**REVIEW OF PLANS** *for*

**FLOOD CONTROL** *and*  
**RECLAMATION** *on the*  
**PAMPANGA RIVER** *in*  
**CENTRAL LUZON**

*by the*  
**U. S. BUREAU OF RECLAMATION**

**December 1962**

DRAWING No. USBR I  
TO ACCOMPANY REPORT BY LARSON, GIBBS & GARDNER  
DECEMBER 1962

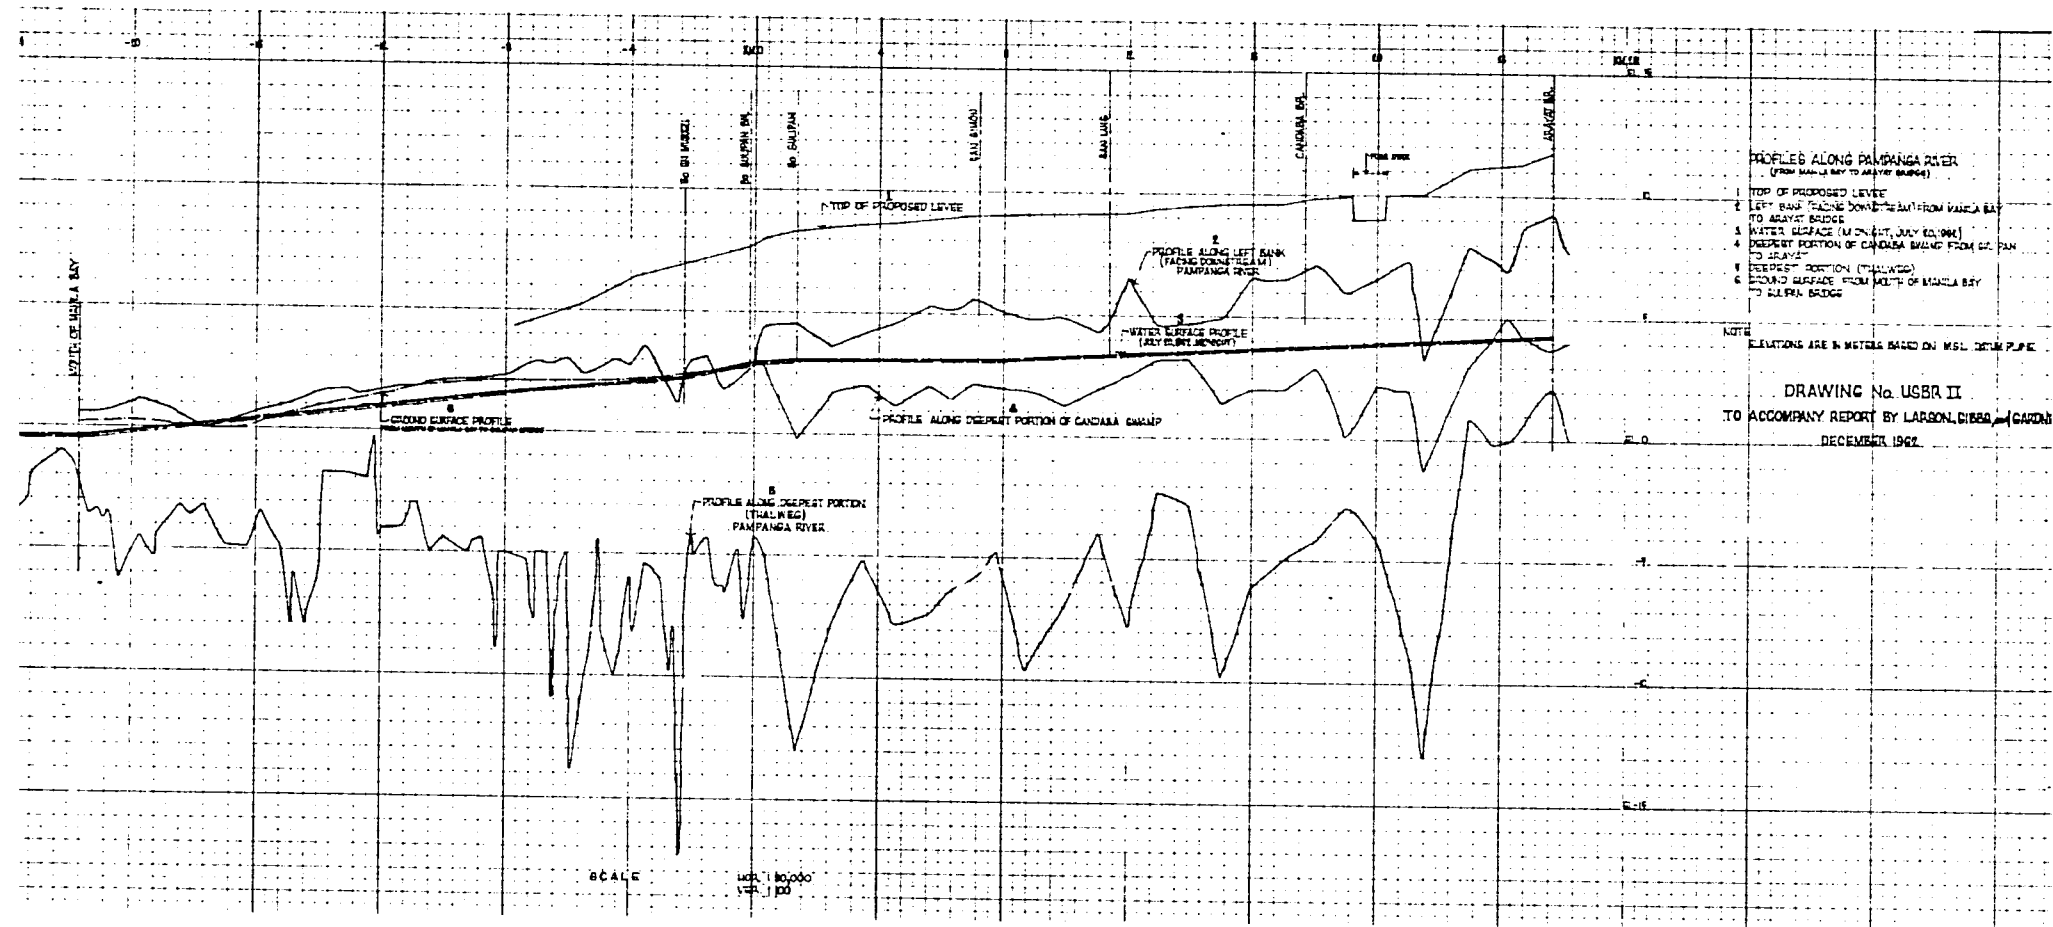
The features of Scheme III as well as the location of four of the potential multi-purpose dams are shown on Drawing No. USBR-I. Table I of this report, was prepared to show the features, estimated construction cost, total cost to date, and remaining cost to complete each feature.

1. Of the three Schemes outlined in the Bureau of Public Works Report on the proposed reclamation of the Candaba and San Antonio Swamps - April 1962, it is our opinion that the general plan outlined under Scheme III should be followed, except for certain modifications which may be found desirable as conditions change and as additional data and studies become available.

3. The water surface profile for the 100-year flood under the routing study, and the actual profile for the 1960 flood seems to show a pronounced restriction in the vicinity of Calumpit. This is apparently caused by the ring-levee protecting Calumpit, and the Bagbag, Calumpit and Sulipan Bridges. We recommend that further studies and investigations be made to determine the maximum width of spans that can be justified for the Bagbag Bridge. Also, we recommend that design of the bridge incorporate provisions for additional span openings which might be justifiable in the future.
